REQUEST FOR INFORMATION (RFI)

RFI No.: ABF-RFI-003001R01 Submitted By: OSullivan, Bill Pages: 1
 RFI Date: 23-May-2013 Contact Name: Osullivan, Bill Phone No. 510-808-4602
 Pages Attached: 0

Subject: Light Pipe Conduit: Additional Pipe Sleeve Penetrations - Floorbeam PP118 and PP120	
References:	
Sub/Sup: ABF	Sub RFI #:
Response Required by: 30-May-2013	Response affects critical path activity?

To: Caltrans
Attn: Bill Shedd, Martin Chandrawinata, Stanley Ku
Project: 04-0120F4 - SAS
RFI Date: 05/23/2013
RFI No: 3001R01
Subject: **Light Pipe Conduit: Additional Pipe Sleeve Penetrations - Floorbeam PP118 and PP120**

SKETCH SK-RFI3001R01-E101

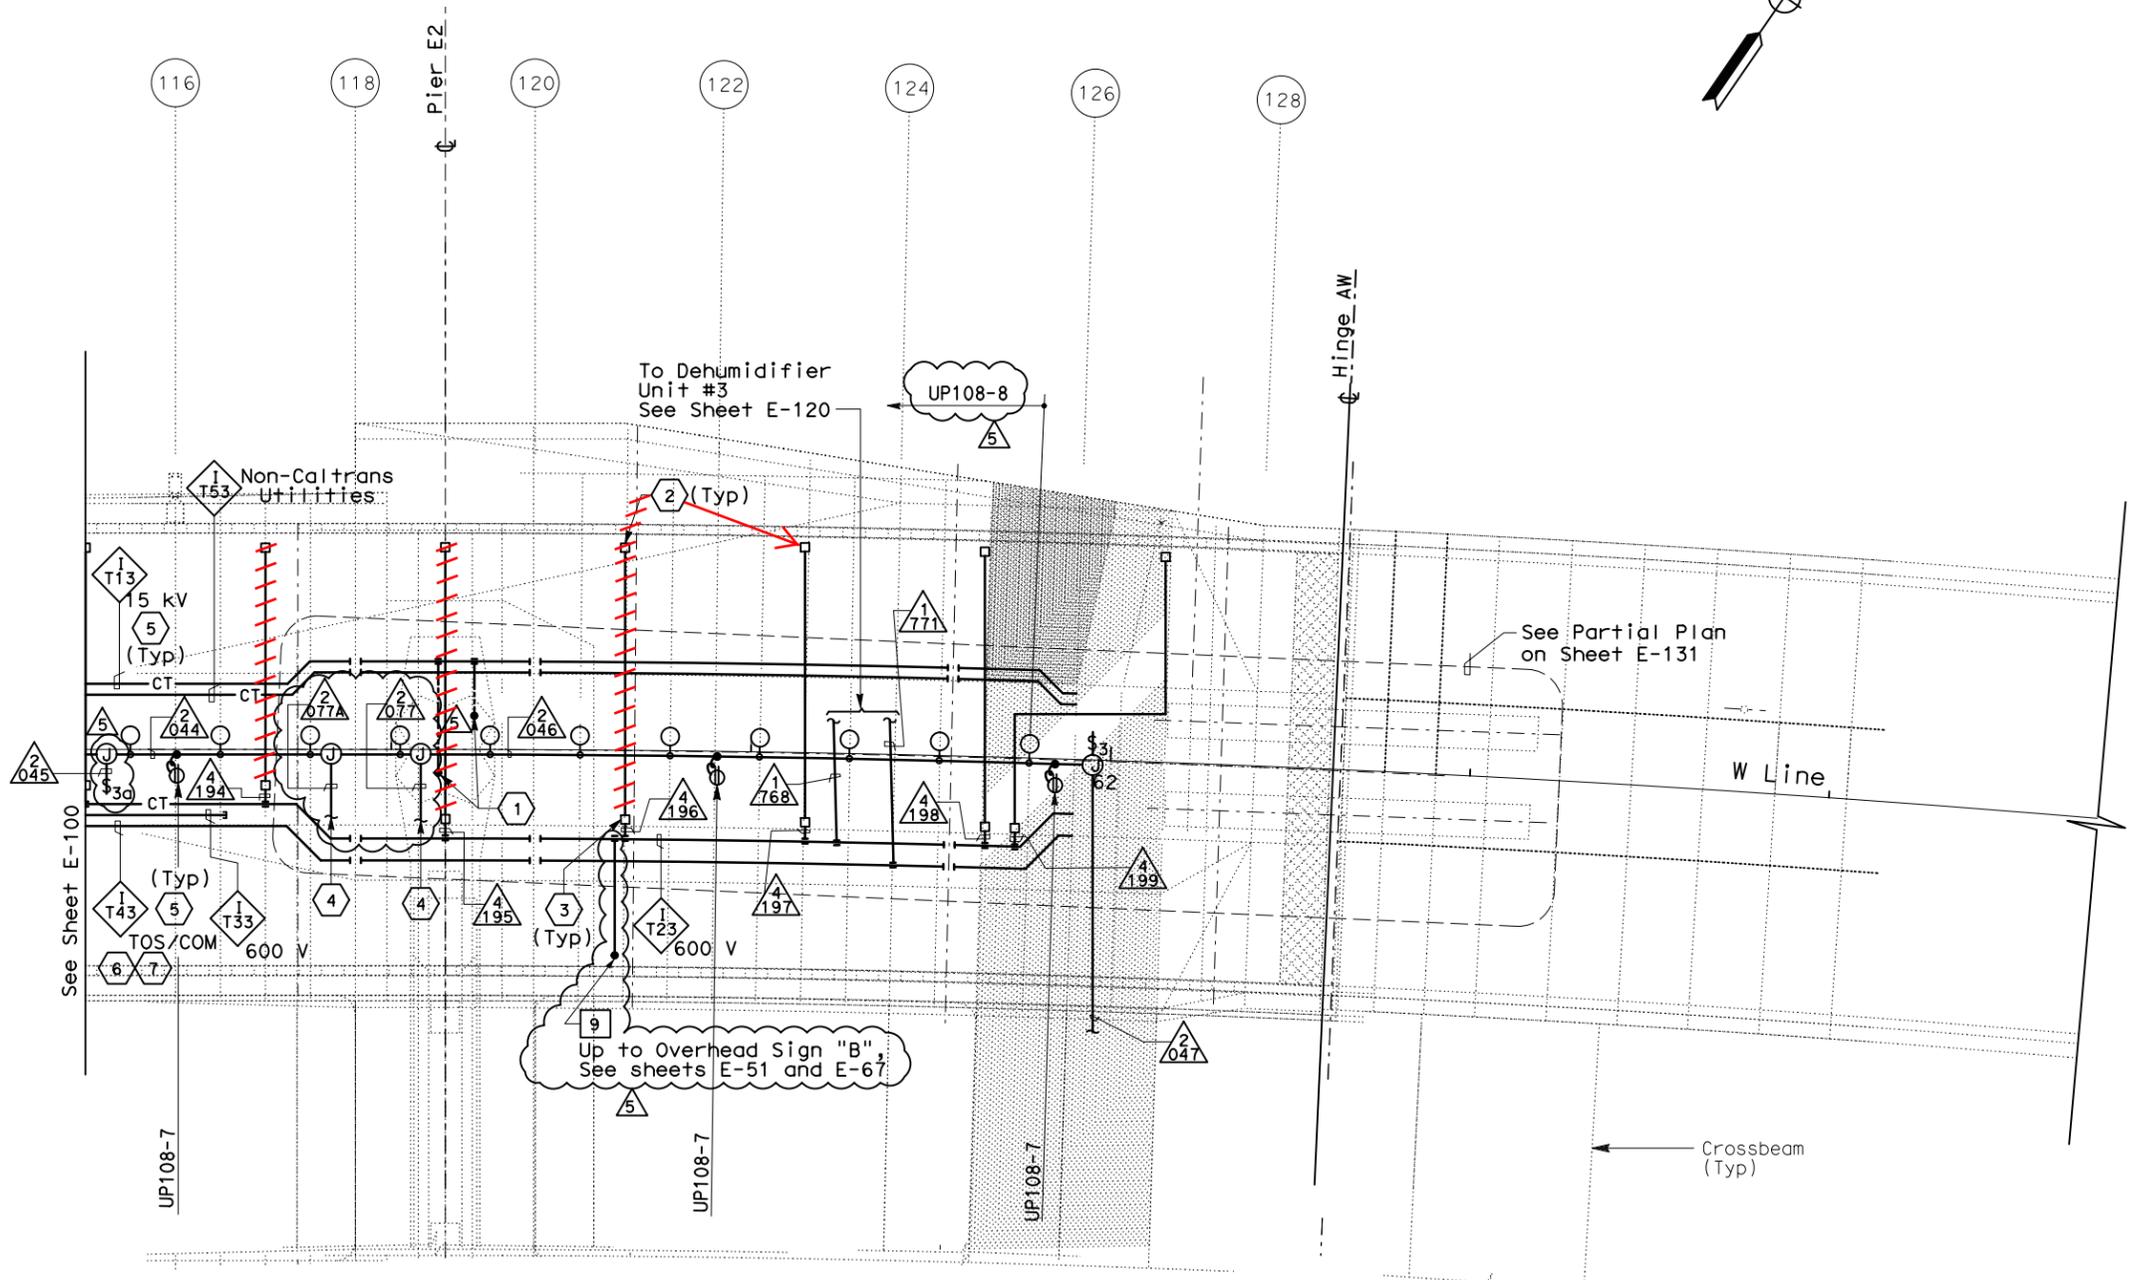
Confirm that the additional penetrations referenced in RFI-3001 R0 will not be performed under the SAS contract.

The Contractor's proposal to omit installation of the referenced penetrations and pipe sleeves for future light pipe conduit is acceptable. As such, the associated PB-2L pull boxes, conduits and wires from PB-2A shall also be omitted from the contract, as shown in the attached sketch SK-RFI3001R01-E101.

SKETCH SK-RFI3001R01-E101

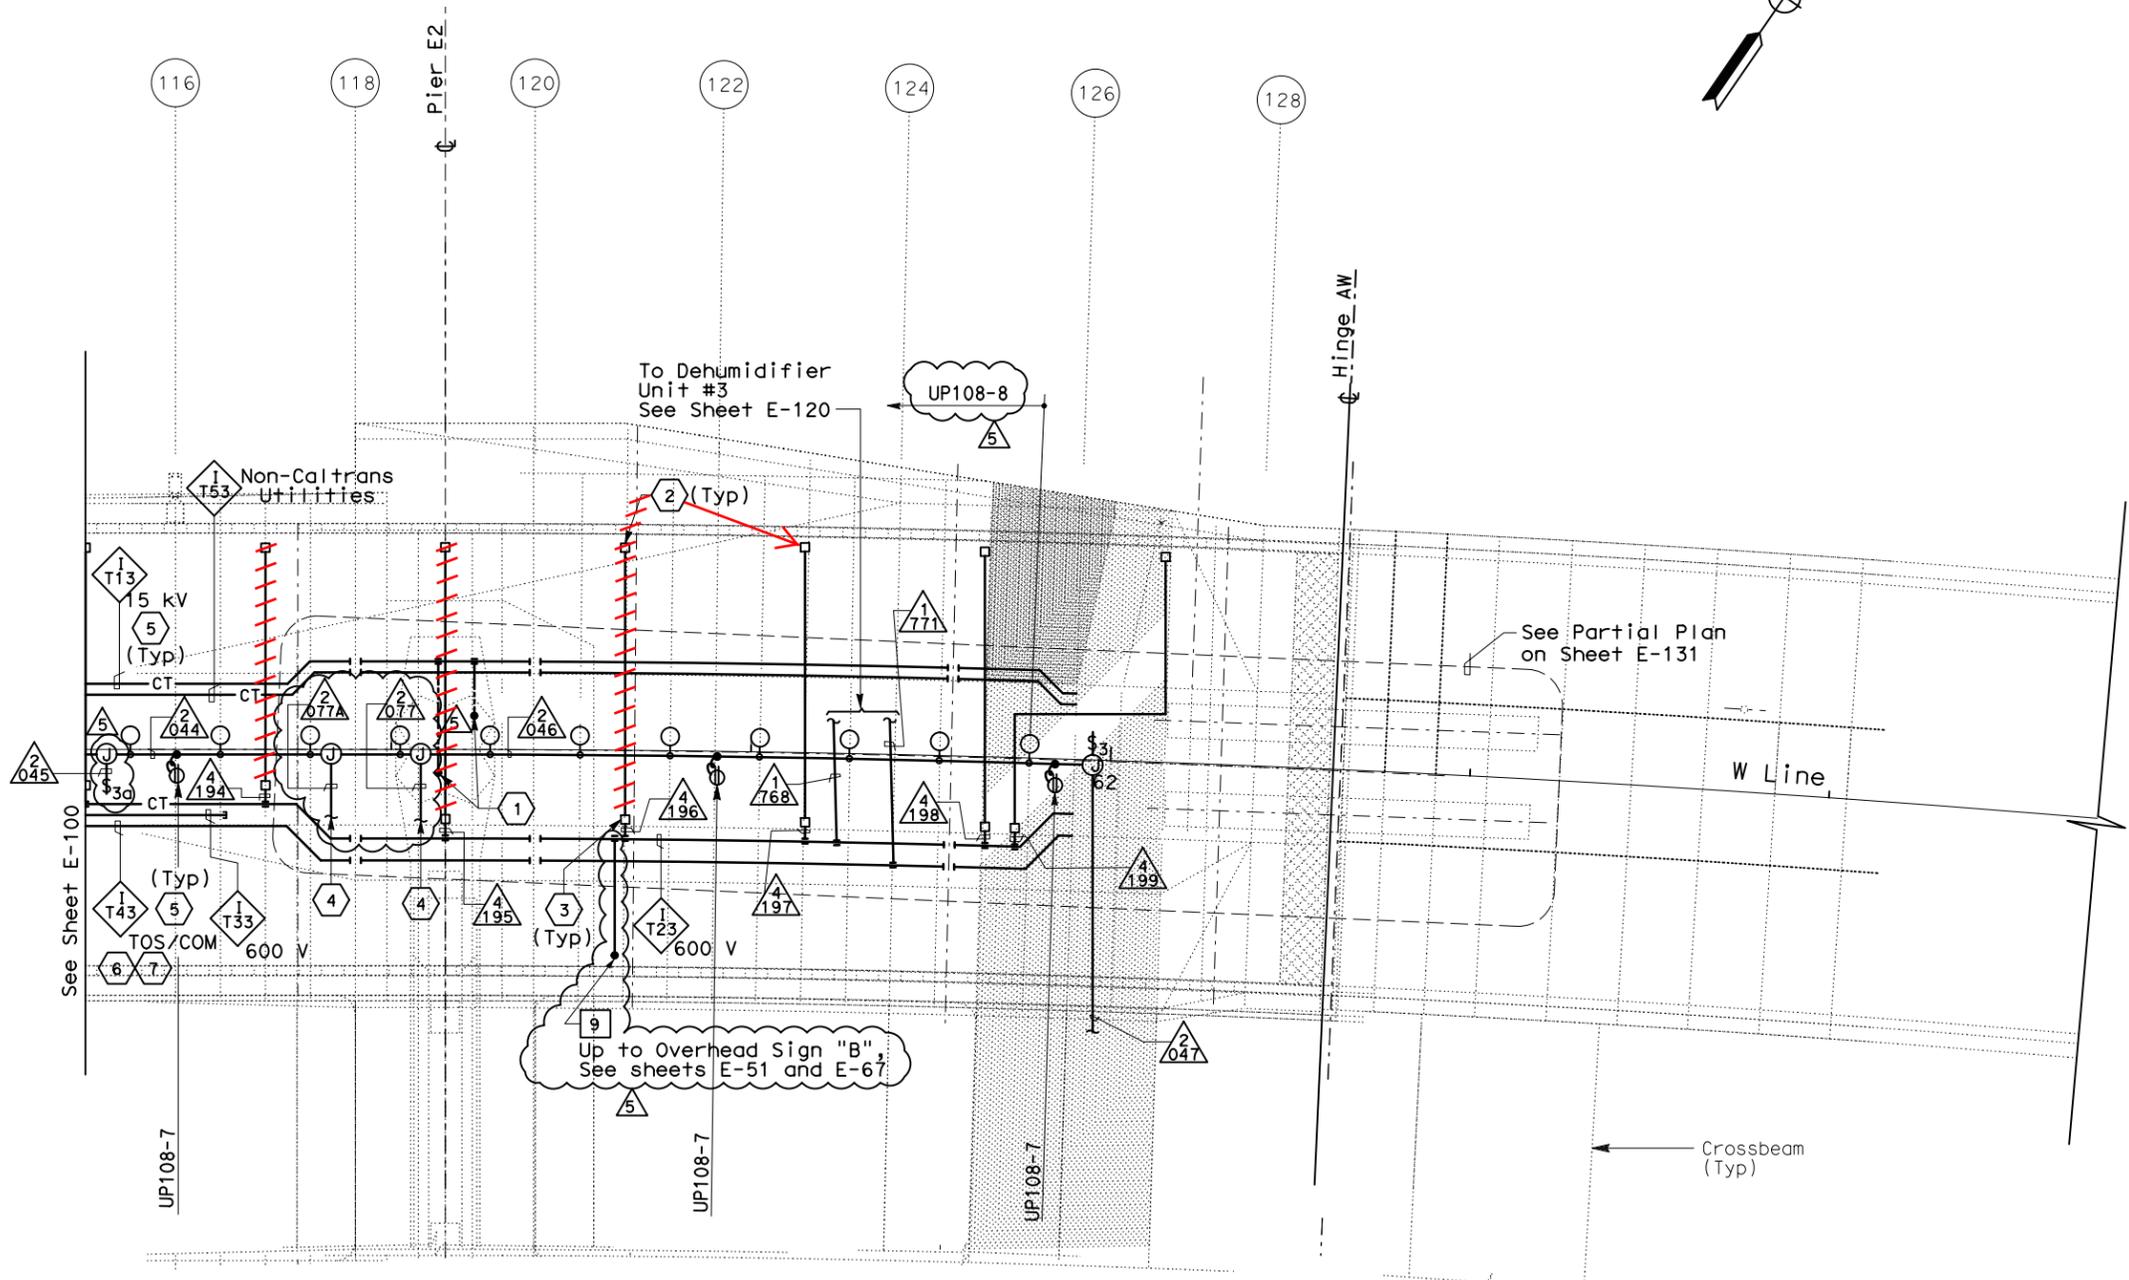
Per the preceding RFI 3001R00, contractor stated that additional pipe sleeve penetrations were required near panel points PP118 and PP120 in the Longitudinal Diaphragm plate of OBG-W along gridline W3 in order to accommodate future light pipe conduits. The contractor's proposal to create penetrations and install pipe sleeves per detail 27C on shop drawing MEPD2 was accepted by PB with no exceptions. Contractor is requesting confirmation that the additional penetrations referenced in the response to RFI 3001R00 will not be performed under the SAS contract.

PB takes no exceptions to the contractor's proposal to omit the penetrations required for future light pipe conduit. PB understands that the associated PB-2L pull boxes and sections of conduit will be omitted from the contract, as shown in the attached sketch SK-RFI3001R01-E101.
